SHADED AREA

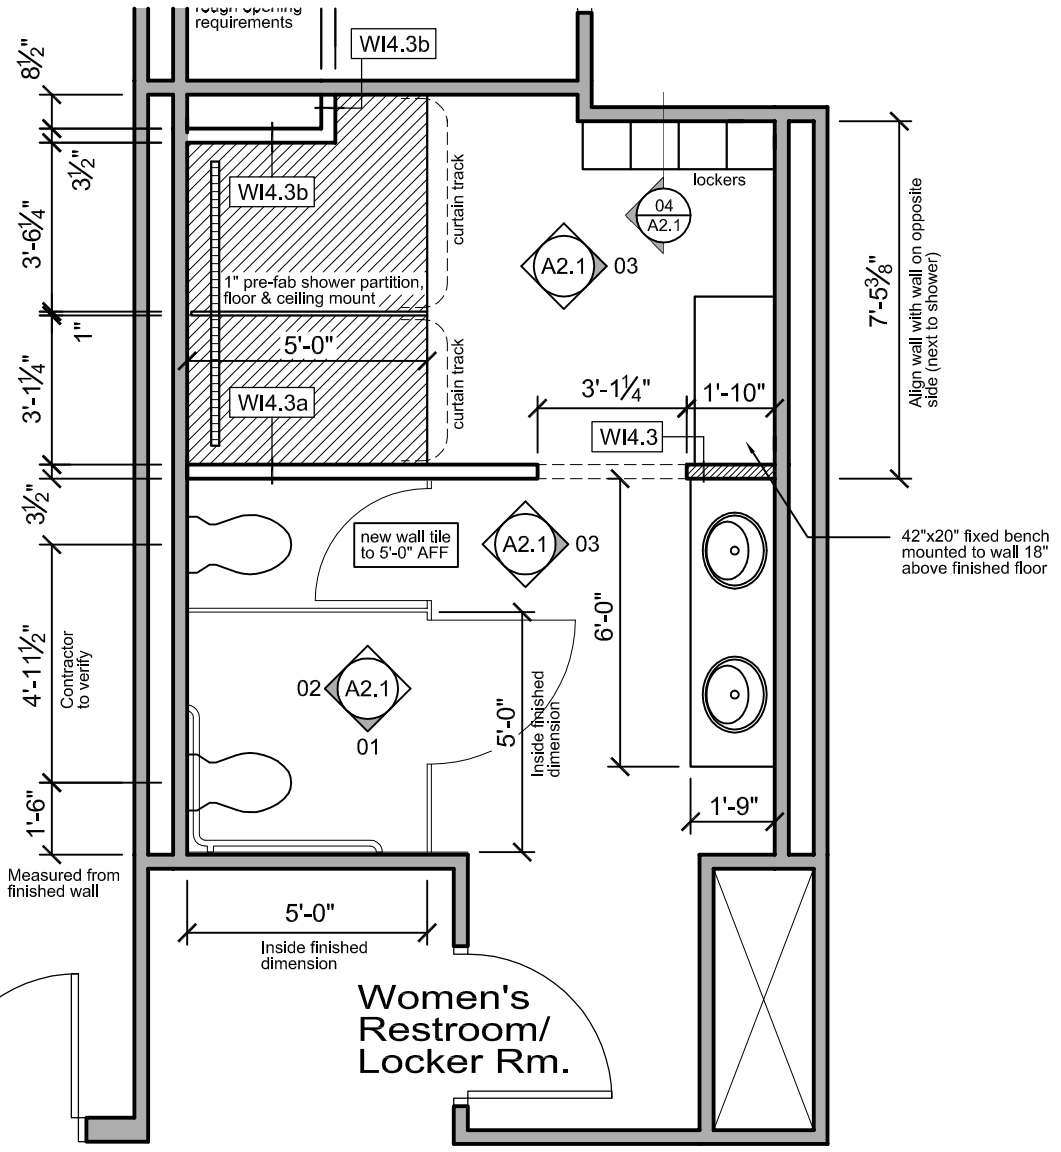
At shaded area new wall tile is to be full height... otherwise new wall tile height is 5' AFF in entire shower and restroom area

At shaded area provide new floor tile, slope to new trench style drain. Existing floor tile to remain outside of shaded area

Provide new trench drain close to existing wall. Slope new tile to drain

Provide new hard lid ceiling in entire shower room

Handicap shower stall (larger stall) to have grab bars, seat and adjustable shower sprayer. Locations per ADA and ANSI ANSI A117.1 guidelines

Rough opening dimensions based on Aquatic 1363 series ADA transfer shower stall unit and Aquatic 36"x36" 4 piece sectional shower unit (non ADA unit)

Adjust/add sprinkler heads and lighting to conform with the design of new space
